## **ADDENDUM NO. 3**

### **City of Springfield CITY COMPLEX**

**Mott MacDonald Project No.: 502100062**

**August 30, 2024**

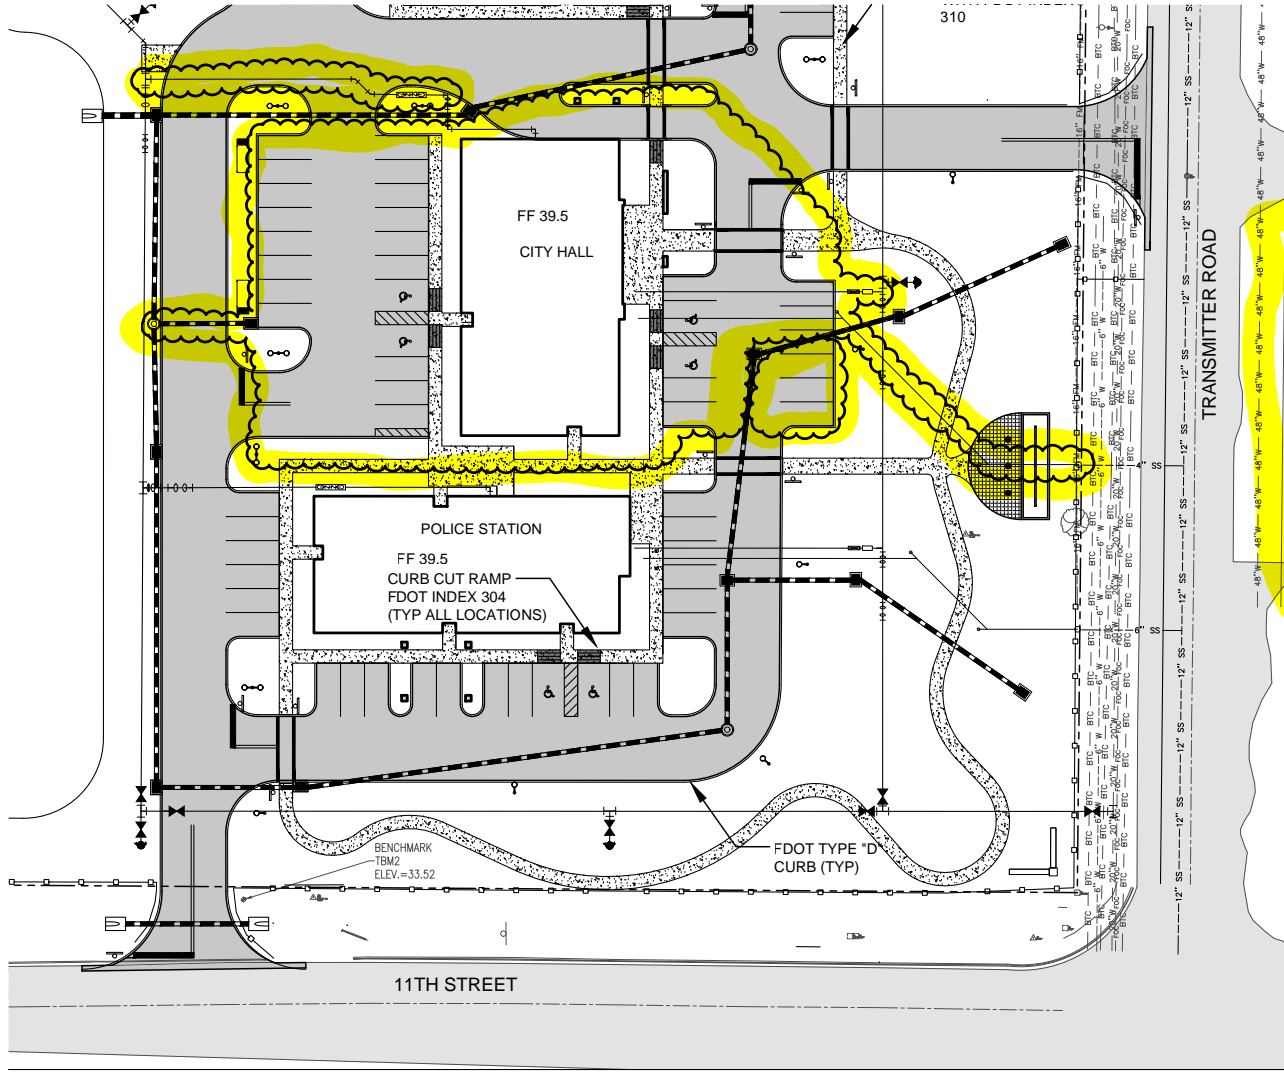
NOTE: The separation of the civil site work for the City Hall is identified by the cloud symbol on the original bid set plans, Volume 3, Sheet G1.0. See below where it is highlighted in yellow. See also the notes.

**ALL CIVIL SITE WORK, UTILITIES, OR ANY OTHER IMPROVEMENTS SHOWN INSIDE THE CLOUD FOR THE NEW CITY HALL, SHALL BE INCLUDED IN BID SCHEDULE #2 "CITY HALL - CITYCOMPLEX".**

**ALL CIVIL SITE WORK, UTILITIES, OR ANY OTHER IMPROVEMENTS SHOWN OUTSIDE THE CLOUD, SHALL BE INCLUDED IN BID SCHEDULE #1 "CIVIL SITE WORK - CITY COMPLEX".**
